Subject: Comments on the Homewood Mountain Resort Ski Area Draft Environmental Impact Report

I have reviewed the January 2011 Draft Environmental Impact Report (DEIR) for the Homewood Mountain Resort Ski Area Master Plan CEP Project (HMR-CEP) for impacts associated with stormwater quality, water supplies, groundwater quality impacts, and land coverage. The 1,253-acre project area is located on the west shore of Lake Tahoe, approximately six miles south of Tahoe City in Placer County, California. The project area is bound by State Route 89 to the east, Ellis Peak to the southwest, and Blackwood Ridge to the north. The Proposed Project includes the redevelopment of the existing ski area north base facility, the residential base area to the south, and development of a mid-mountain lodge and beginner ski area.

SUBJECT: Review of the Draft Environmental Impact Report/Statement (Draft EIR/EIS) for the Homewood Mountain Resort Ski Area Master Plan Project in Placer County – Traffic and Parking Issues

Figure 15-15. Off-Site EIP Project Design Schematic

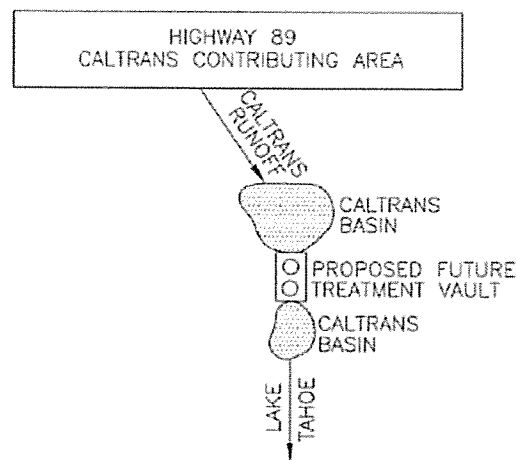
The flows in the controlled Contech lab experiment are dwarfed by actual conditions predicted in the DEIR. The DEIR estimates flows to the system as follow: 10-year event = 3.54 cfs, 25-year = 4.28 cfs, 100-year = 5.39 p. 15-92). These flows equal 1,589 gal/min to 2,419 gal/min, well in excess of the 7.5 gal/min discharge in the controlled lab experiment that is cited in the DEIR.

The DEIR provides no estimates of how the Contech system will work under actual field conditions with predicted 10-, 25- and 100-year events in reducing fine particulate loading to Lake Tahoe. The DEIR should be revised to include real world examples of Contech installations, preferably in the Tahoe basin, and to provide data to demonstrate effective reduction of fine particulates.

If data cannot be provided to demonstrate reduction of fine particulates, redesign of the system should be considered in a revised DEIR. The system, as proposed, is schematically presented below.

To increase the HMR-CEP effectiveness, consideration should be given in a revised DEIR to routing stormwater to an infiltration gallery after treatment by the Contechs system, in a fashion similar to the treatment train that is proposed for stormwater treatment for the project. Discharge to a basin, especially during high-flow conditions will not be as effective in reducing TSS.

Project No.: Homewood Ski Resort			
Title: 2005 Orthographic Imagery and 1970-1971 Detailed Site Investigations Map, North Parking Lot			
	Project No.: 438	Drawn By: JAC	Figure: 2
	Approved: MH	Date: 04.13.2011

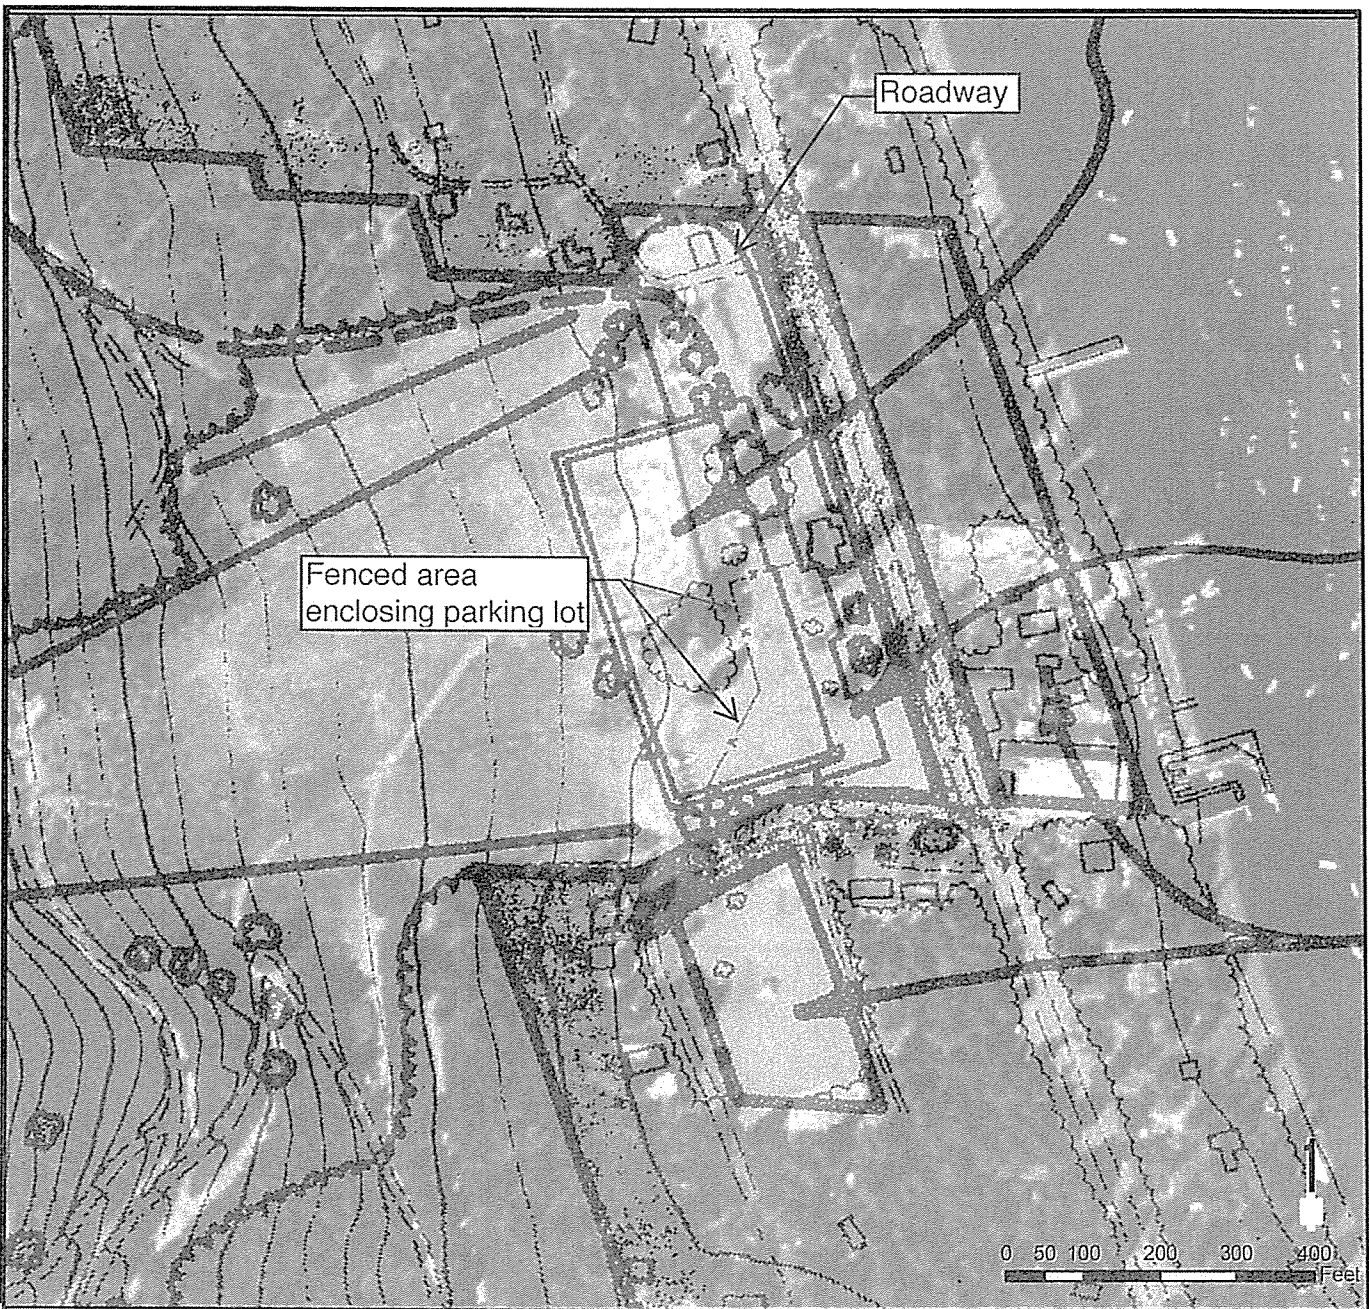
Additionally, we have conducted an analysis of the North Base parking lot and have determined that the majority of the parking lot was not in existence as of February 10, 1972. Figure 2 shows an overlay of a map prepared on the basis of conditions that existed as of November 1971 (Attachment 2), arguably the same conditions that would have existed on February 10, 1972 given that the winter season would have prevented any further development.

A revised DEIR should be prepared to verify the existence of the roads of February 10, 1972 in areas already restored or in areas proposed for restoration. All roads not in existence as of that date should be eliminated from discussions regarding banking of land coverage. Instead, roads that have been restored should be included for credit for restoration of disturbed lands to meet TRPA goals.
